Seismic Walkdown Checklist (SWC)

Equipment ID No.: 1FC8762B

Equipment Description: U1 SPENT FUEL PIT HX OUTLET VALVE

Project: Braidwood 1 SWEL

1FC8793 7-18-12 072

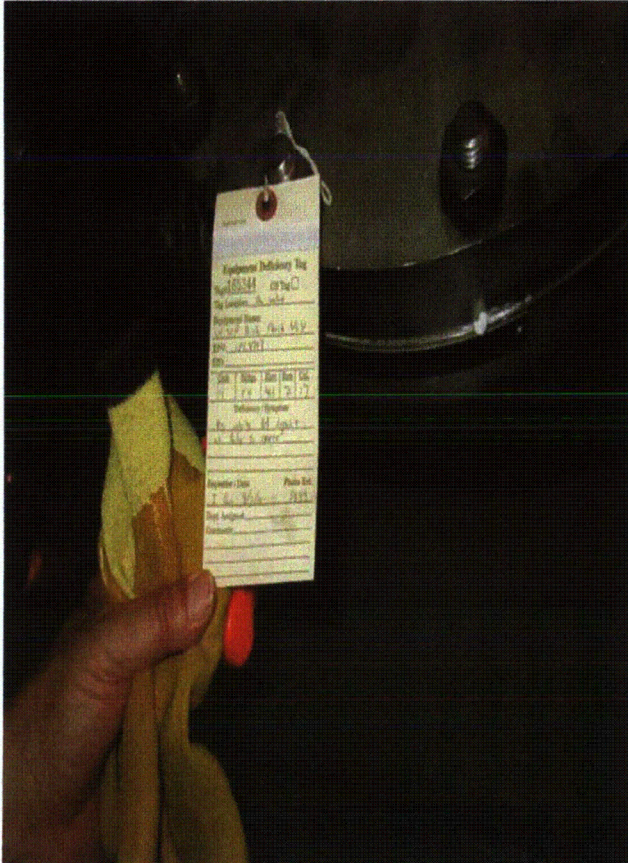
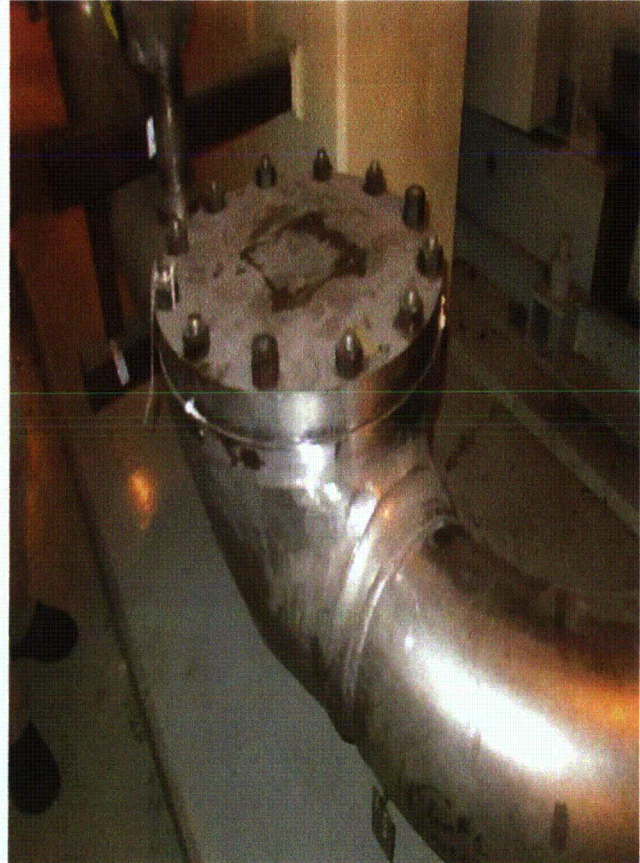
11. Have you looked for and found no adverse seismic conditions that could adversely affect the safety functions of the equipment? Yes
Boric Acid leak identified on tag. No adverse seismic impact.

Equipment ID No.: 1PA14J

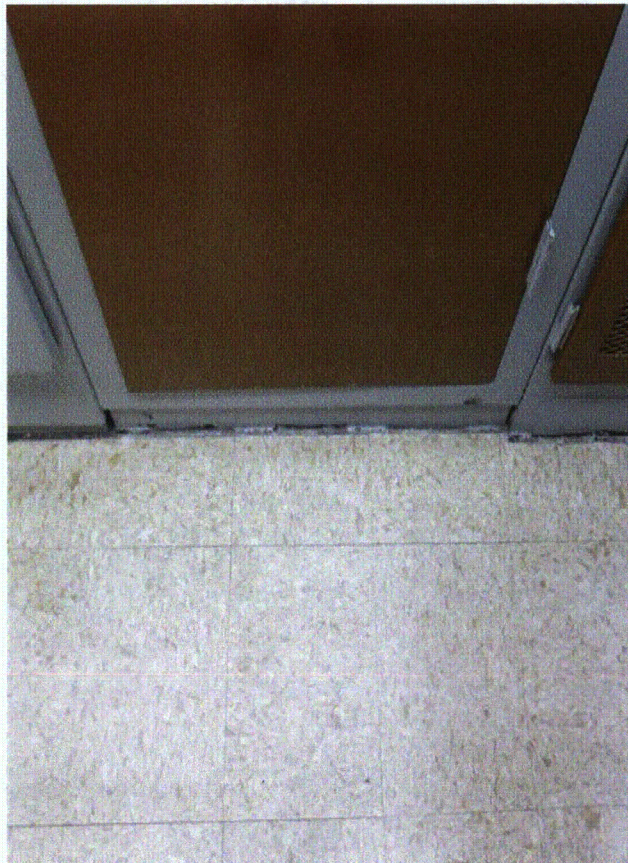
5. Is the anchorage configuration consistent with plant documentation? (Note: This question only applies if the item is one of the 50% for which an anchorage configuration verification is required.) Yes
Drawing 20E-0-3391C Revision BM Mounting of Sequencing & Act. Cabinet 1PA14J
Weld exceeds drawing requirements

Equipment ID No.: 1PA28J

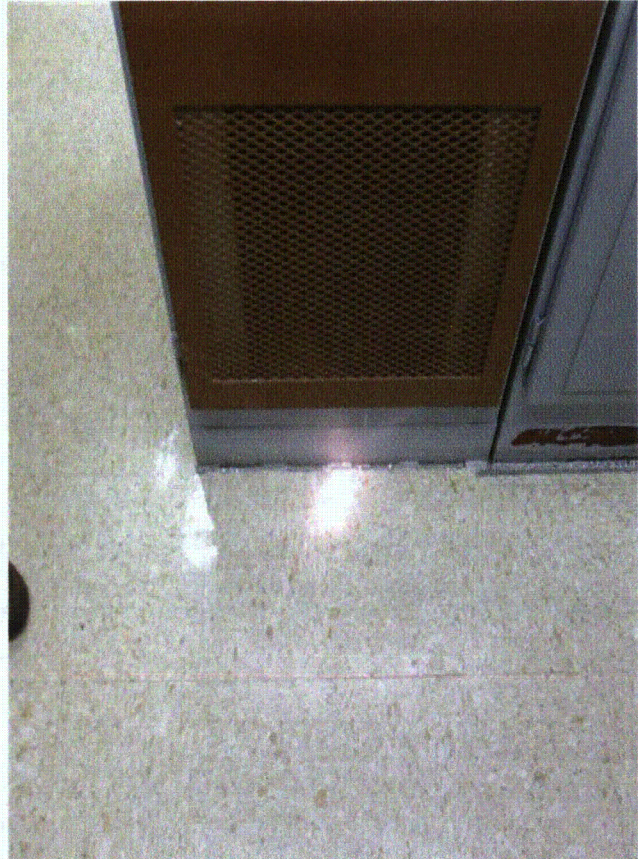
5. Is the anchorage configuration consistent with plant documentation? (Note: This question only applies if the item is one of the 50% for which an anchorage configuration verification is required.) Yes
*Weld exceeds drawing dimensions. Drawing 20E-0-3391C Revision BM
Mounting Detail for Miscellaneous Racks*

Equipment ID No.: 1PA34J

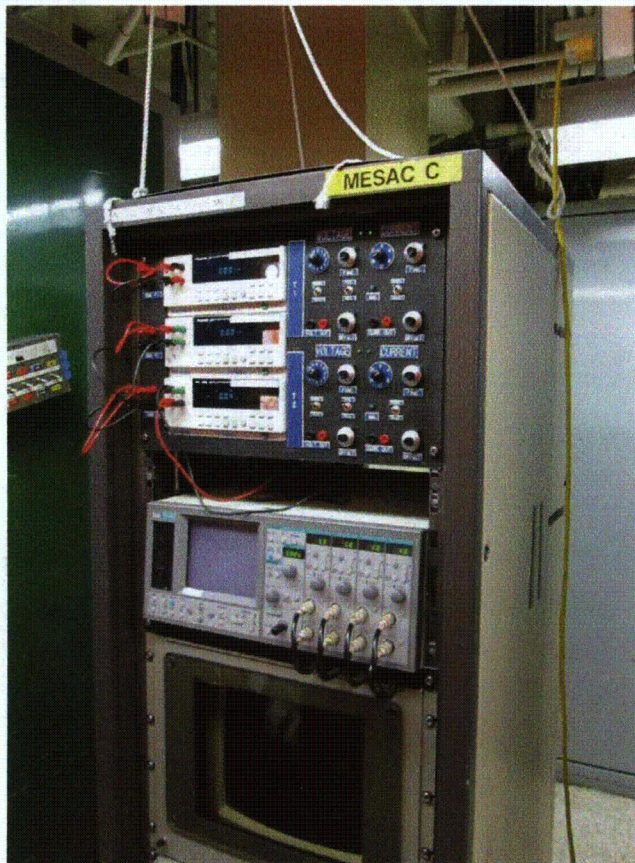
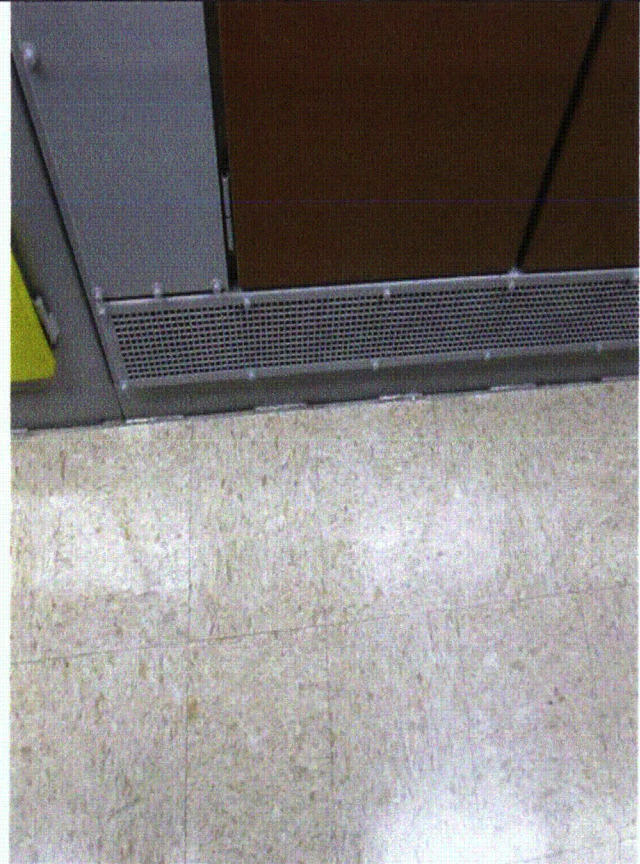
5. Is the anchorage configuration consistent with plant documentation? (Note: This question only applies if the item is one of the 50% for which an anchorage configuration verification is required.)
*Weld exceeds drawing dimensions. Drawing 20E-0-3391C Revision BM
Mounting Detail for Misc. Racks* Yes
